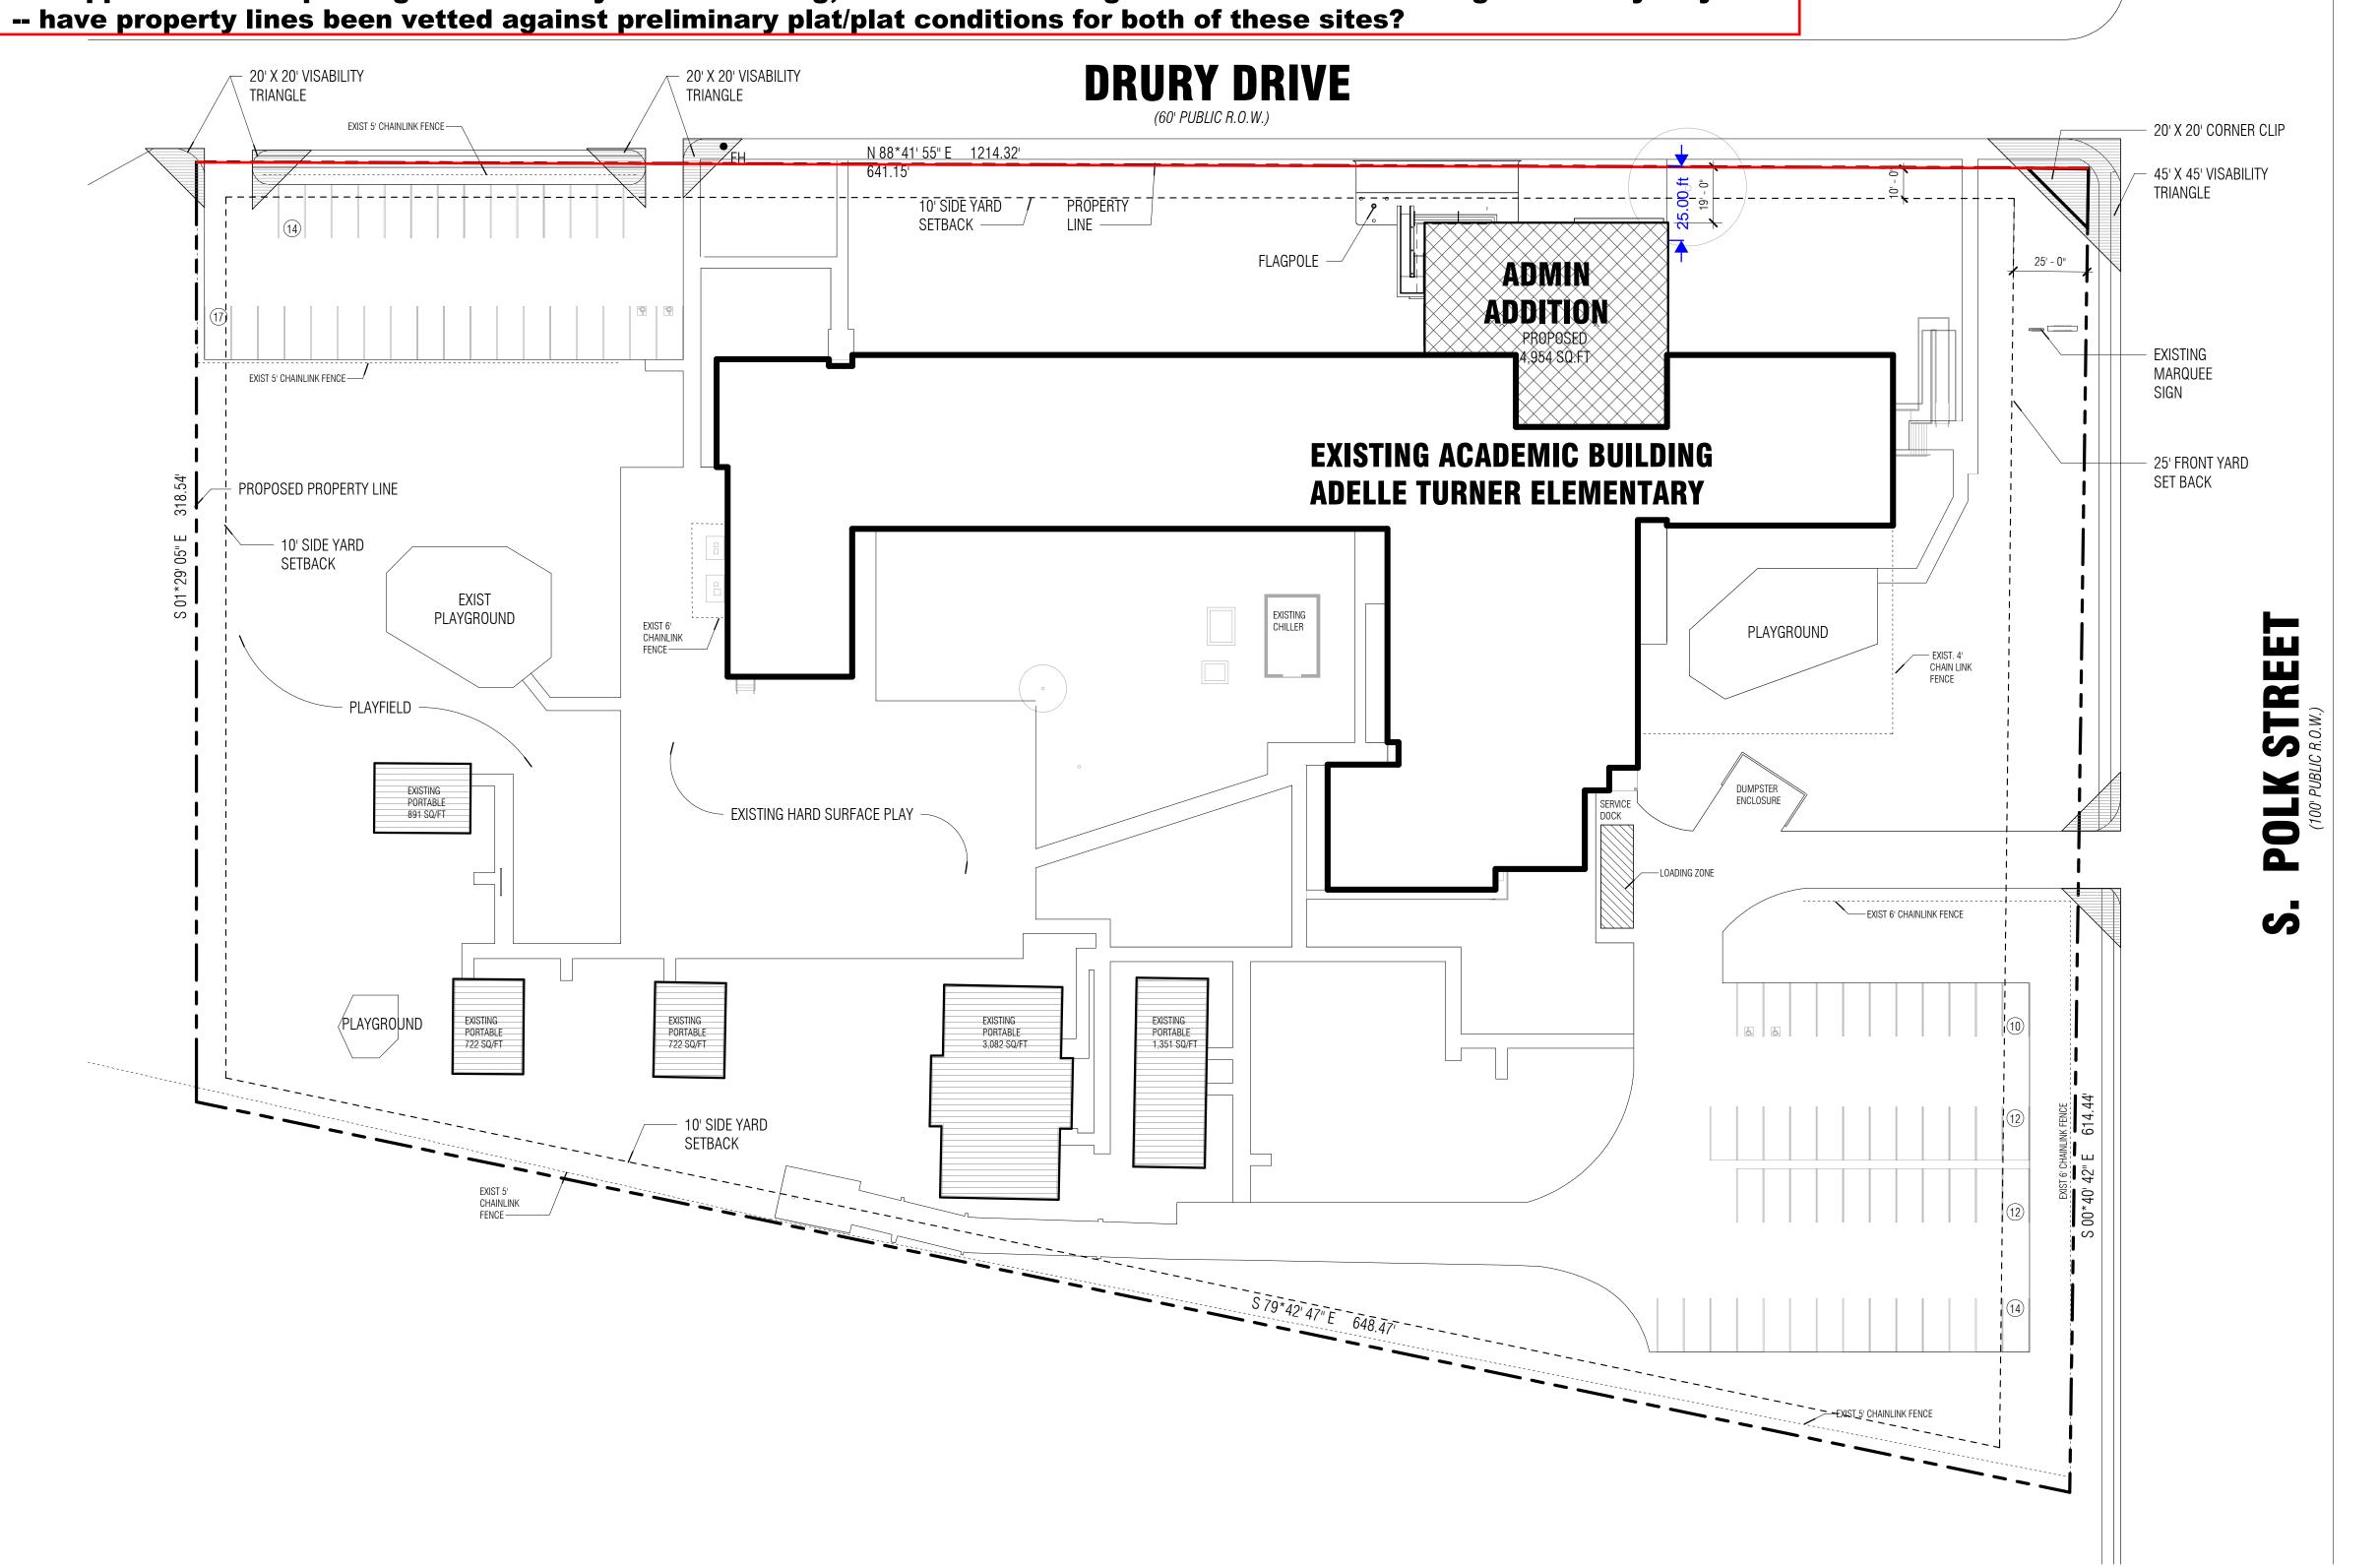
- -- drawing is not to the stated scale (ex: setback called out as 10' measures to 11')
- -- setback at Drury is 25' due to continuity with the adjacent lot (Drury is a front yard for the Atwell/Bedford lot) [refer to 25' setback line extended along Drury frontage on the site plan for Atwell/Bedford. overlay of plans shown below with Atwell/Bedford in grey and Turner in blue]

01 | SITE PLAN

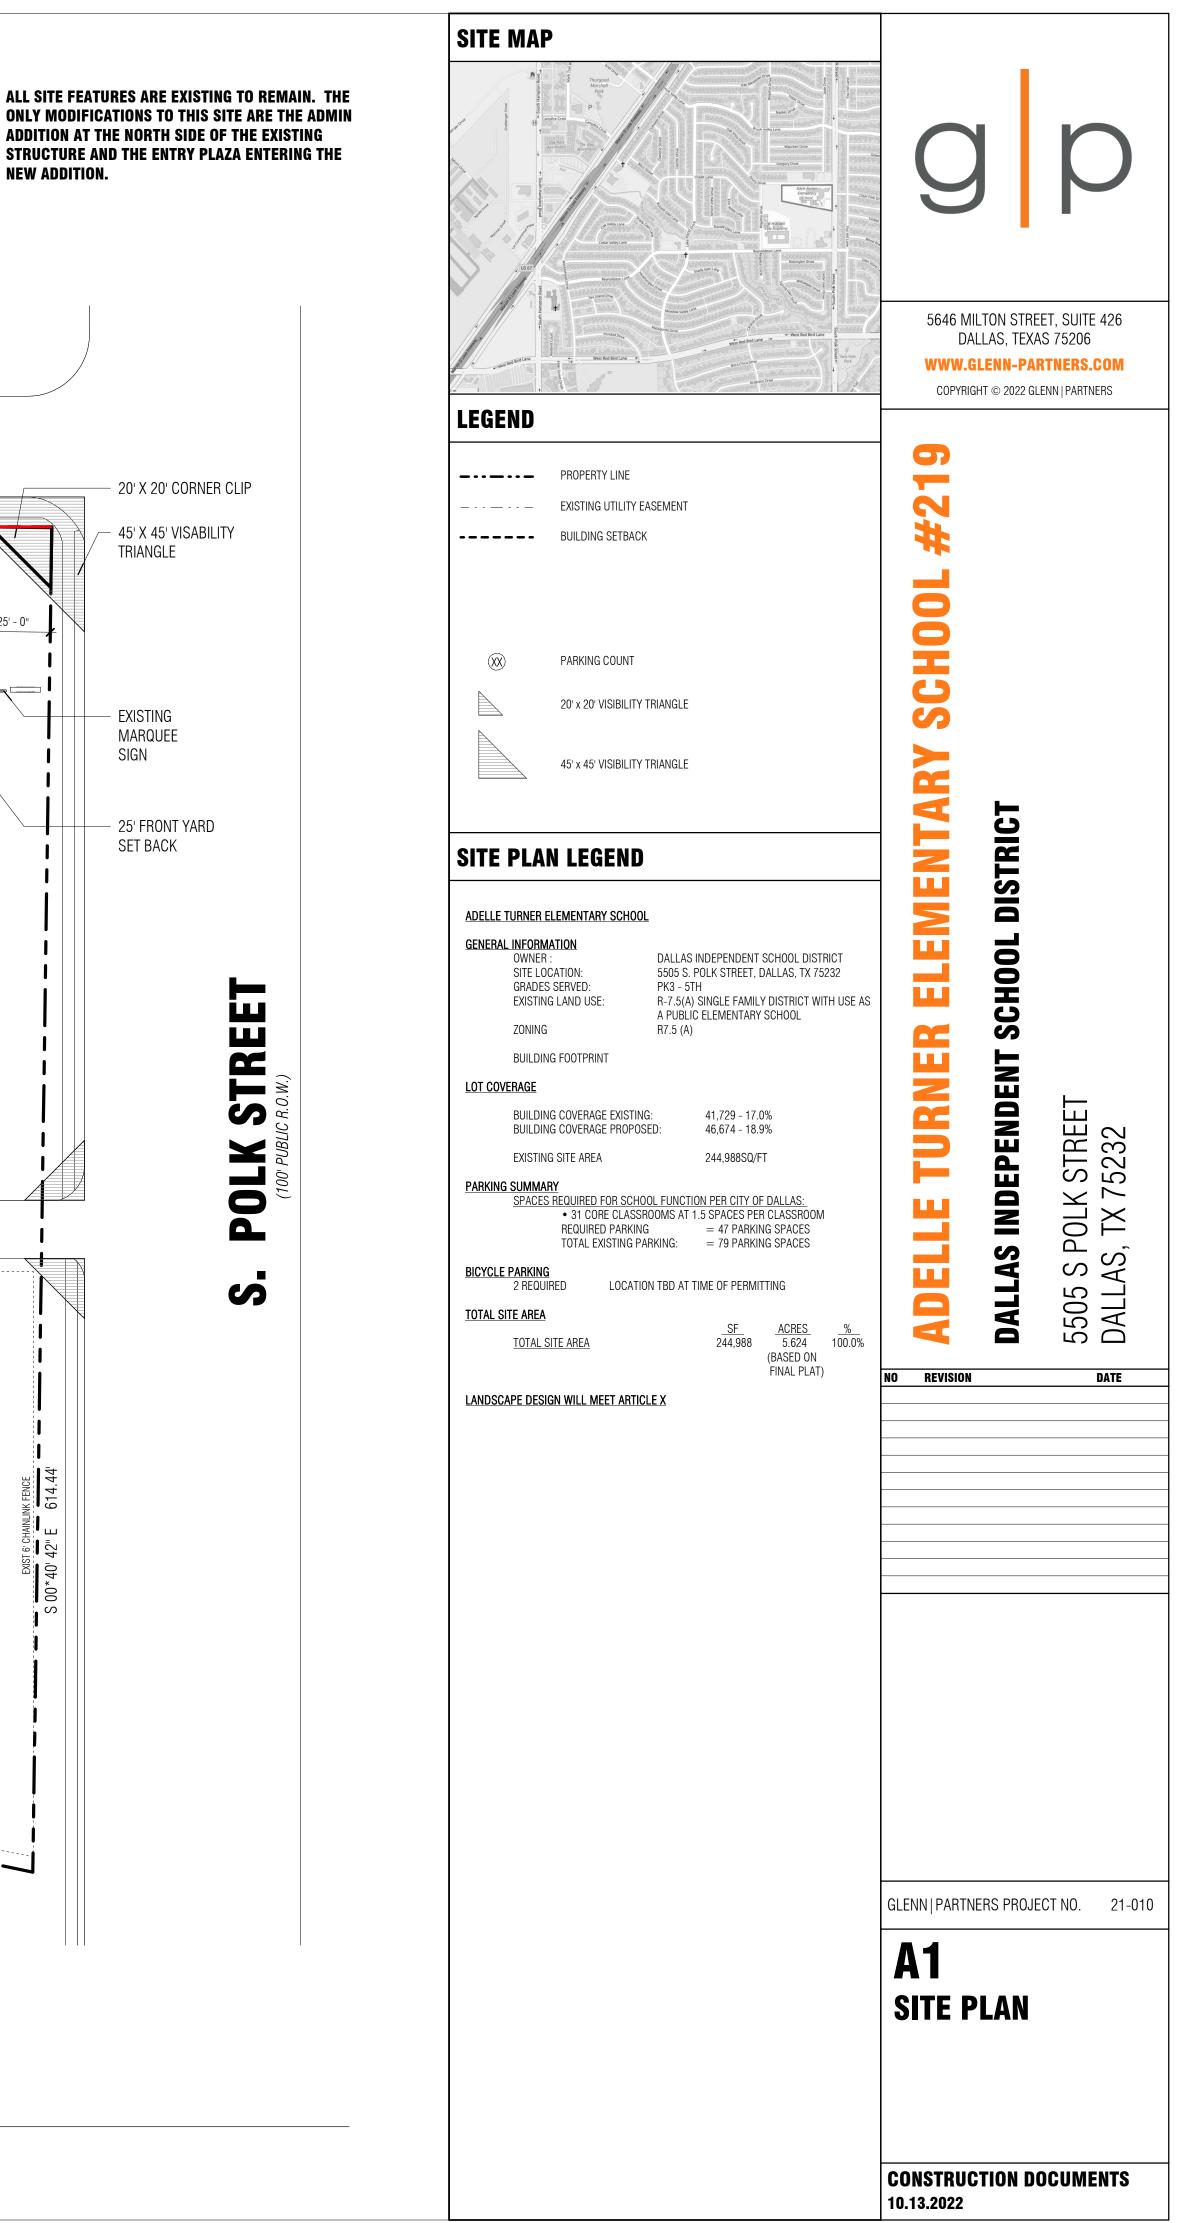
- -- proposed improvements may not encroach into 25' setback at Drury (existing improvements become nonconforming)
- -- it appears that all parking within front yards is existing, so no issue as long as these are not reconfigured in any way
